Product Change Notification

Date Issued :	February 12, 2025	PCN Number :	516605
Reason for Change :	Obsolete		
Description of Change :	This notification is to inform you about the obsolescence of parts referenced in this notice. Please connect with your Molex Sales Engineer for additional queries related to possible alternative solutions.		
Reason for Short Notice :	Tool Breakage		
Planned Implementation Date :	May 23, 2025		
Recommended replacement parts :	Please see the attached replacement parts list .xls file.		
Last Time Buy Date for Obsolete Parts :	March 30, 2025		
Last Time Ship Date for Obsolete Parts :	April 30, 2025

39303041 / 39303043

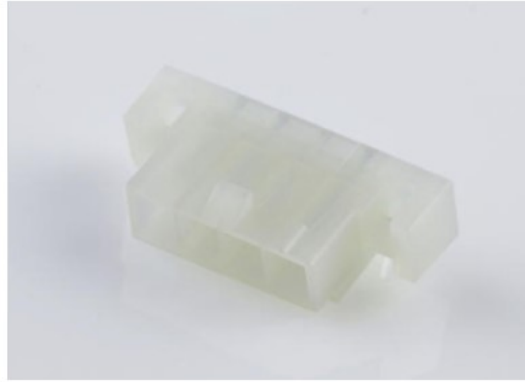
- Mold is at end of life, no sales in the last two years, no justification to retool
- Product Impact
 - Part numbers being eliminated
- Part Number Impact
 - 39303041
 - Replacement 39303045 – Peg version instead of flange
 - 39303043
 - Replacement 39303047 – Peg version instead of flange
 - 39013183
 - Replacement 39012181 – Panel Mount with ears
- Qualification Reports, PPAPs, and samples – N/A
